PARTS & SERVICE NEWS

REF NO.	AA04135
DATE	August 10, 2004

SUBJECT: IMPROVE ROUTING OF BRAKE COOLING SYSTEM TUBE

PURPOSE: To introduce to the field a more reliable routing of brake cooling system tube.

FIGURE 1. CURRENT BRAKE COOLING SYSTEM TUBE ROUTE

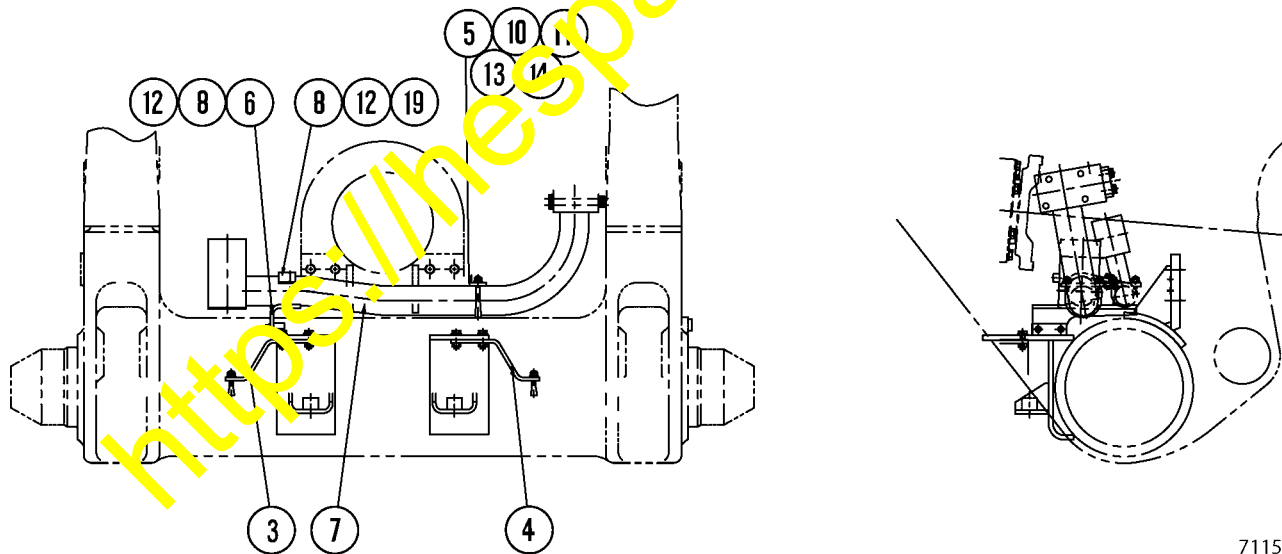
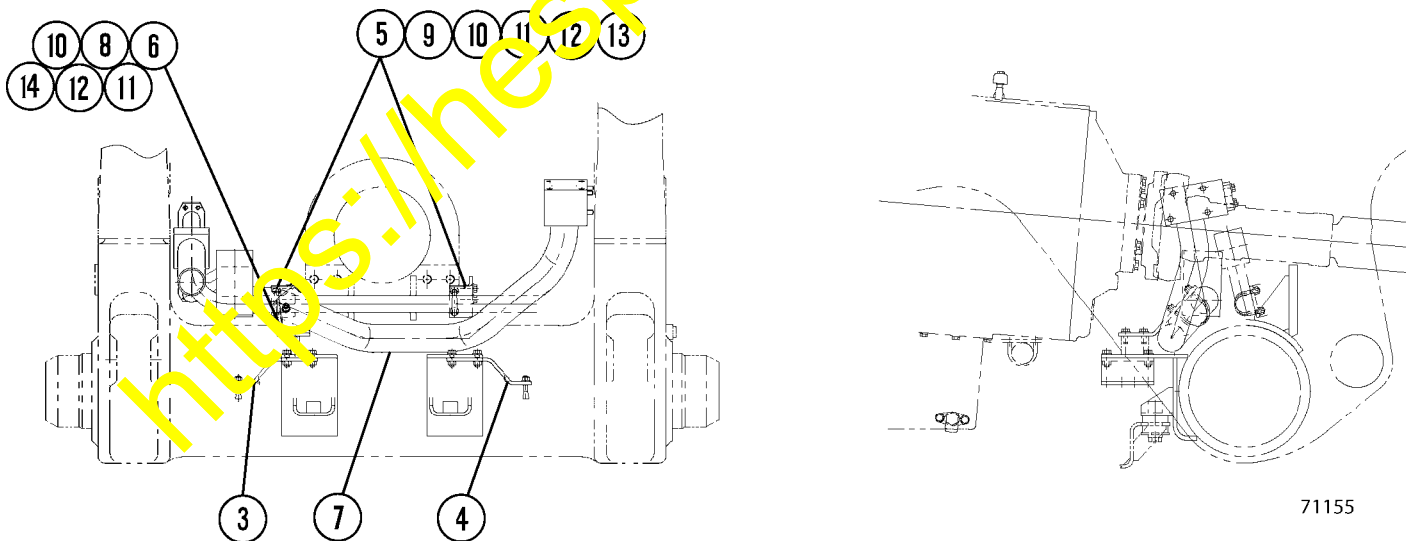
Some trucks in the field could experience damage to brake cooling system tube (7, Figure 1). The damage can be caused by a joint failure in the rear drive shaft. After the joint fails, the drive shaft breaks loose and is constrained by the driveshaft guard. The brake cooling system tube is too close and is often hit by the draft shaft. When the brake cooling system tube is damaged, oil leakage may occur. This Parts & Service News introduces a better route for the brake cooling system tube and a rework procedure for the driveshaft guard.

1. Remove existing brake cooling system tube (7, Figure 1).

6. Assemble new brake cooling system tube (7, Figure 5) with hardware shown.

FIGURE 5. NEW BRAKE COOLING SYSTEM TUBE ROUTE

FIGURE 2. BRACKET REMOVAL

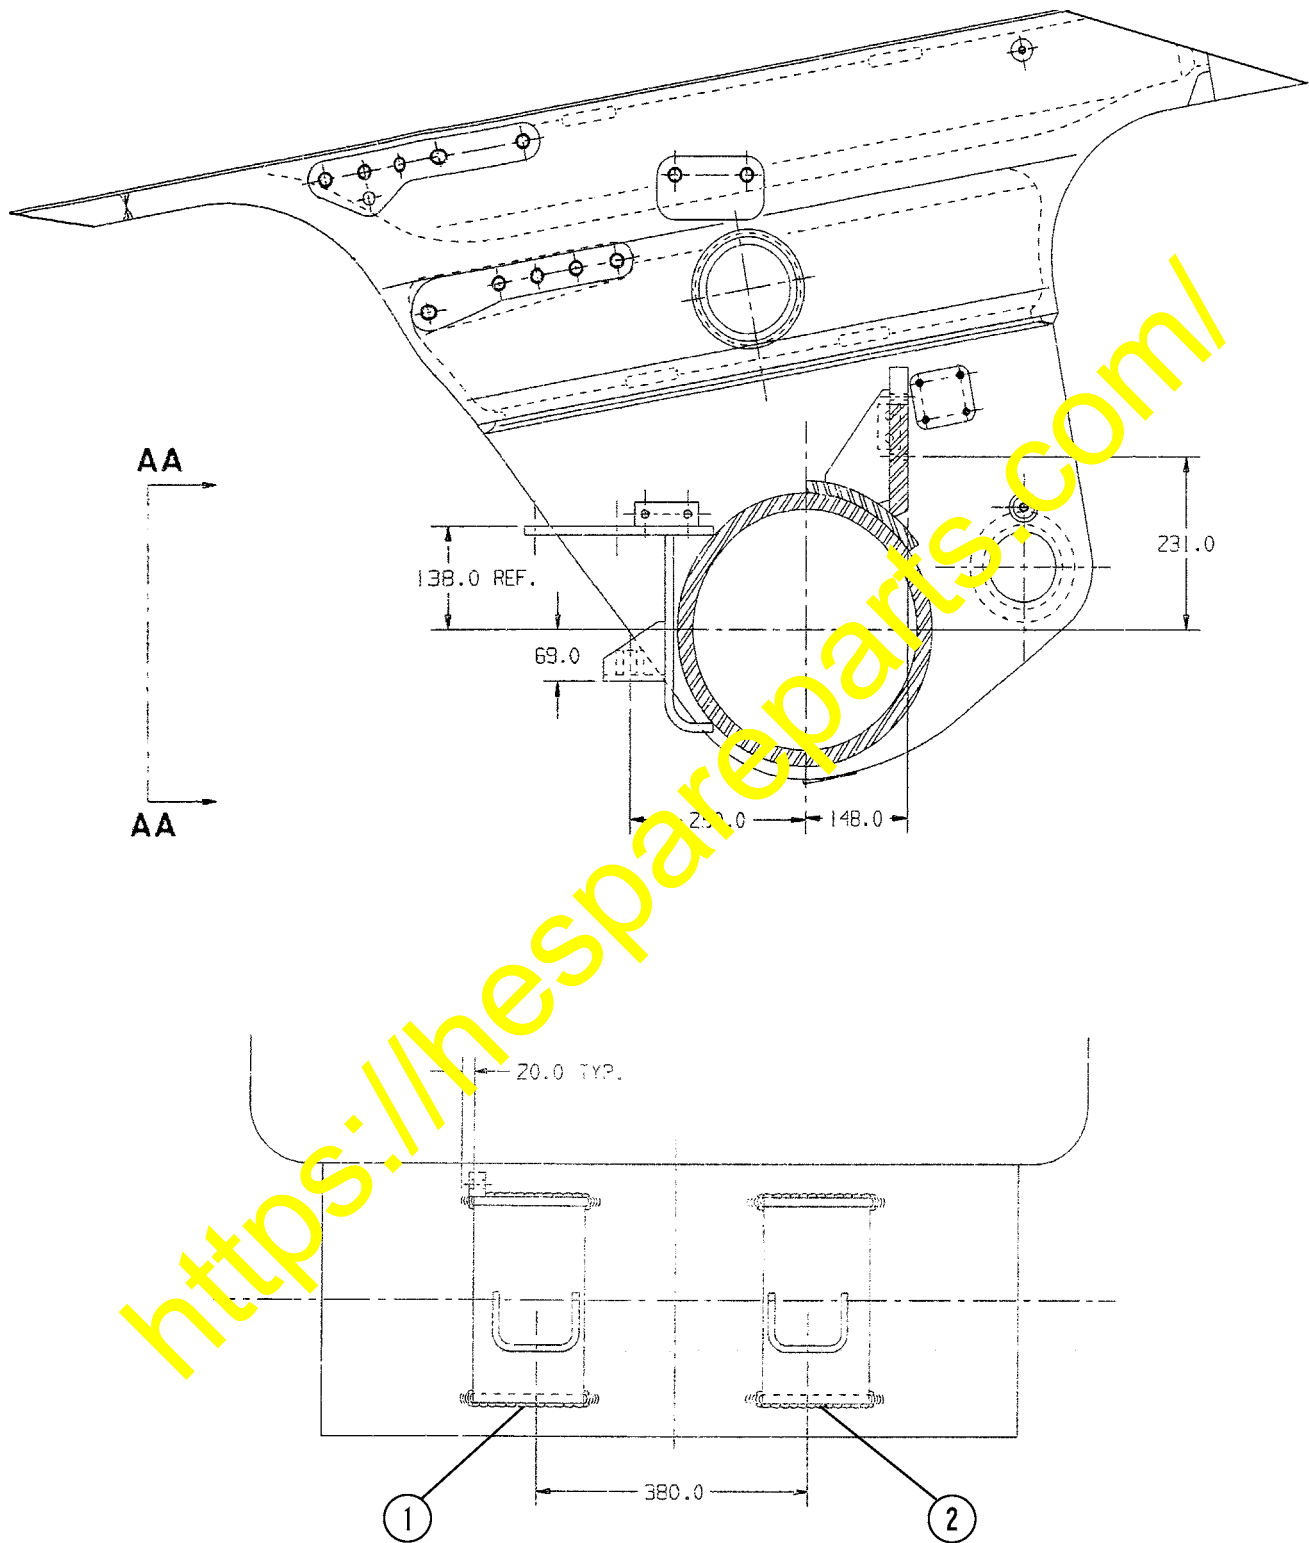
2. Remove existing brackets (1 & 2, Figure 2) from frame.
3. After bracket removal, grind smooth and clean frame surface.

FIGURE 3. BRACKET INSTALLATION

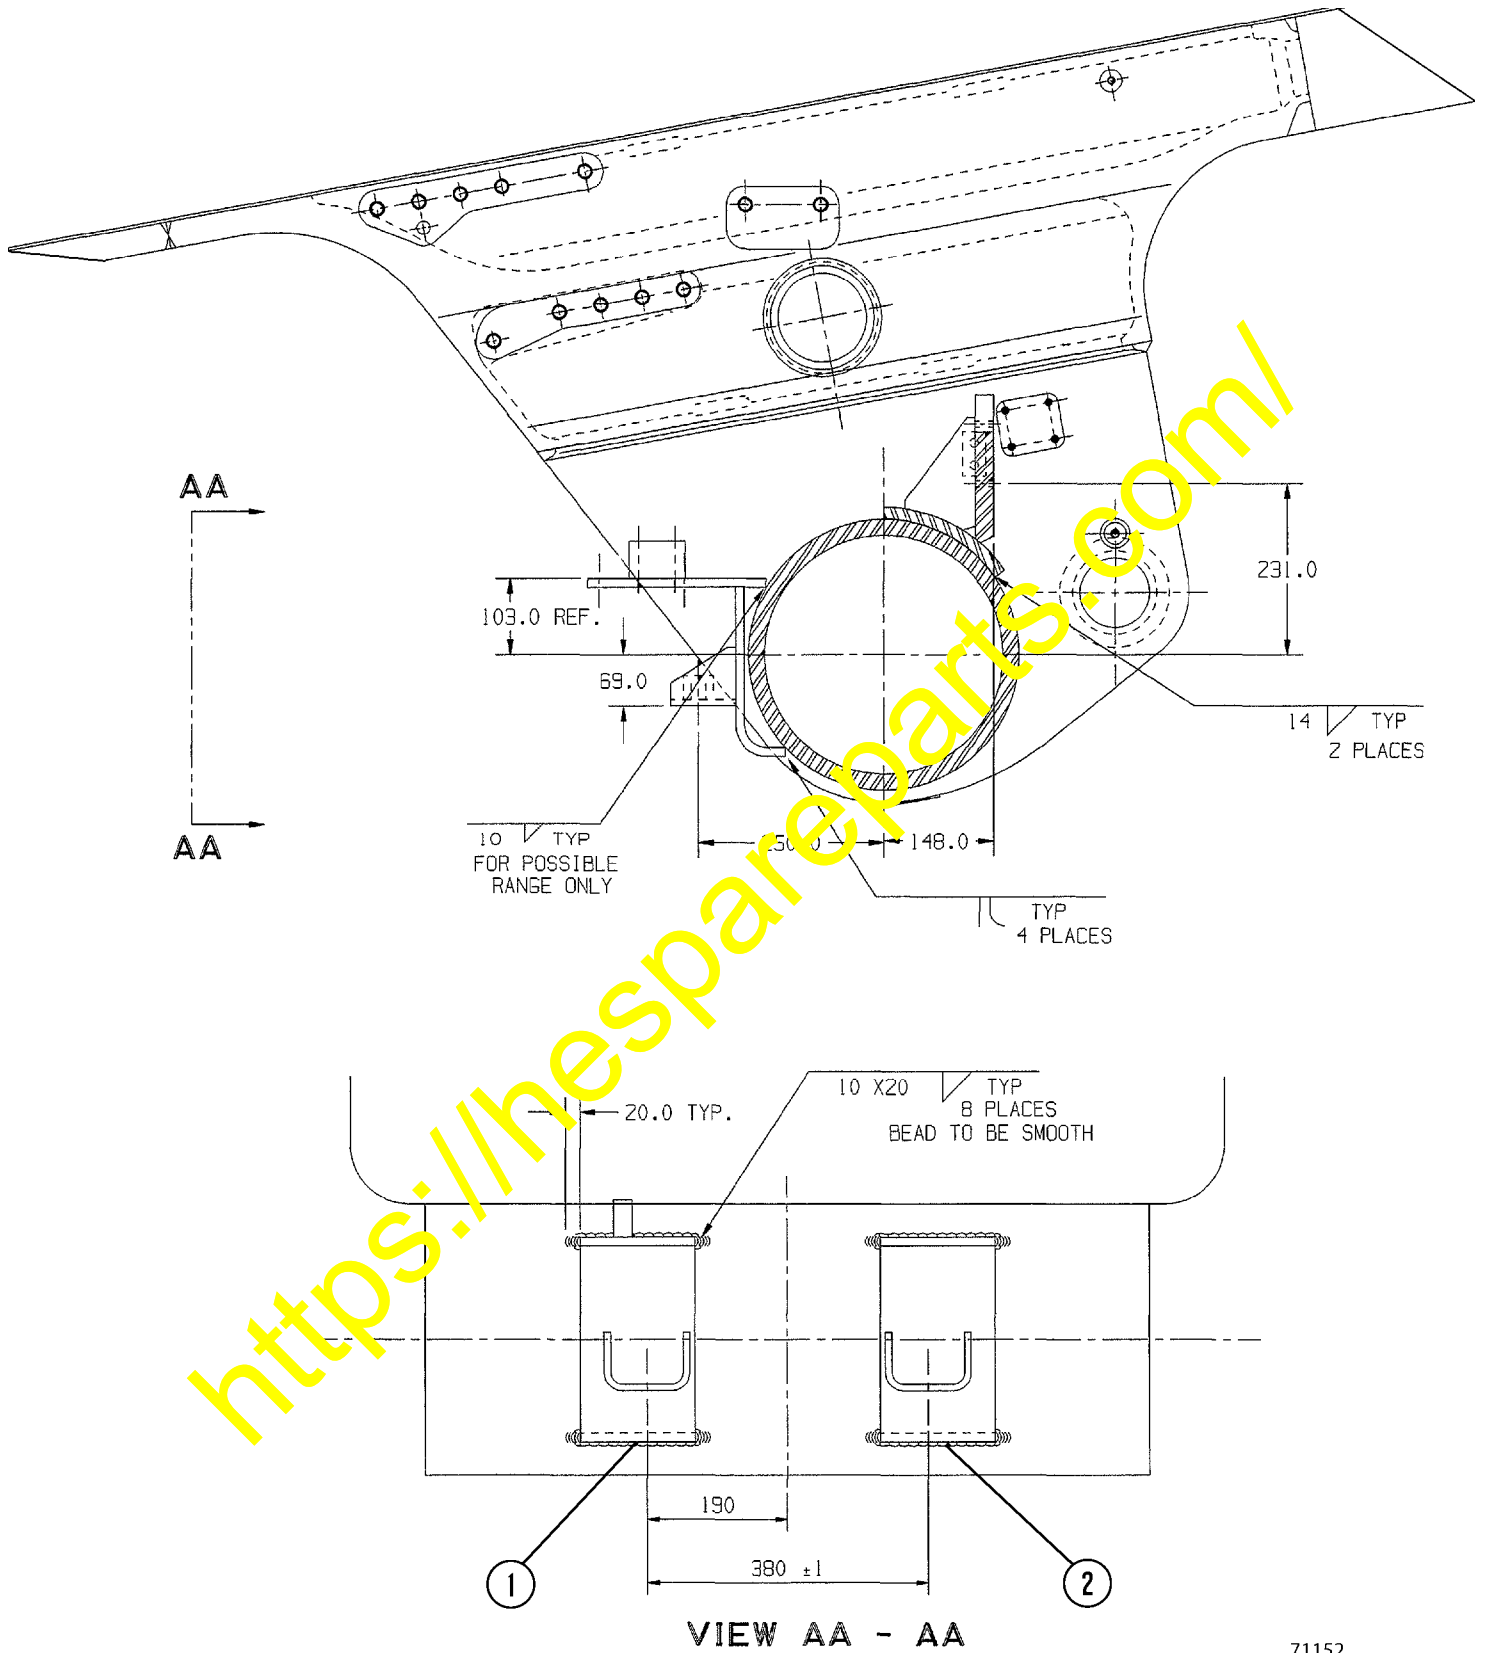
4. Weld brackets (1 & 2, Figure 3) as shown.

FIGURE 4. DRIVESHAFT GUARD REWORK

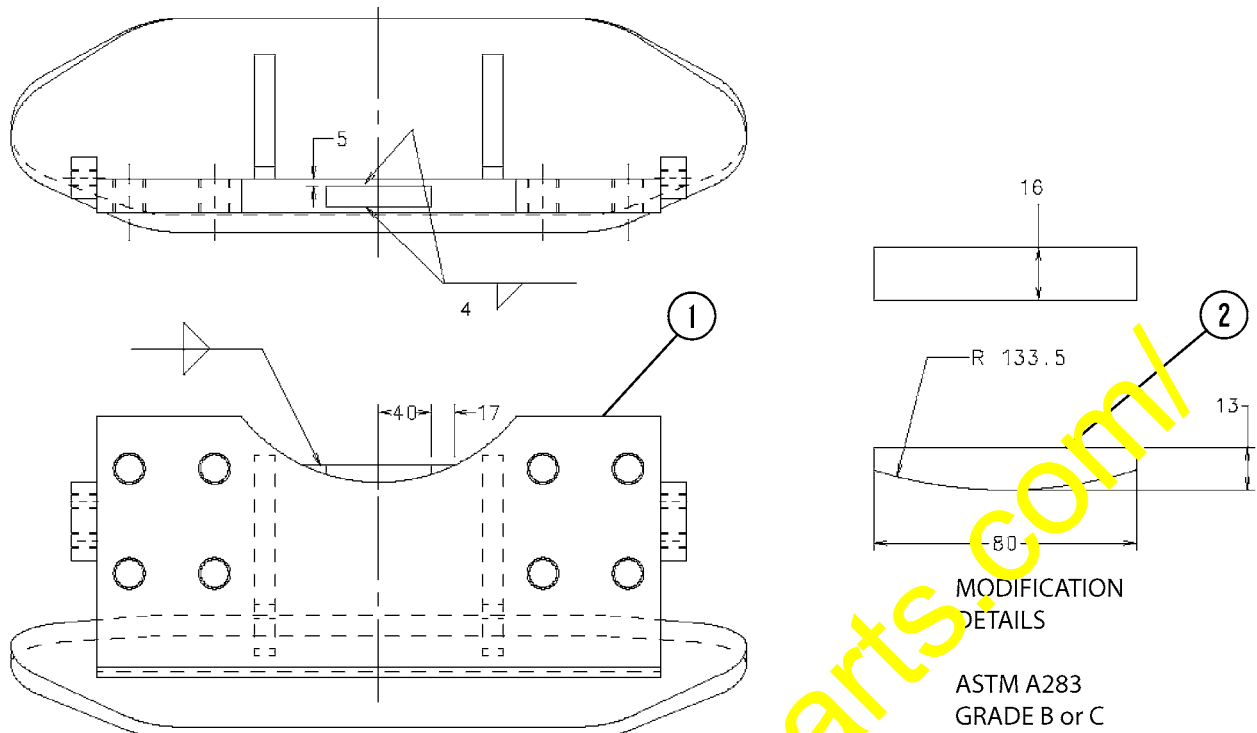
5. Rework driveshaft guard (1, Figure 4) as detailed below.
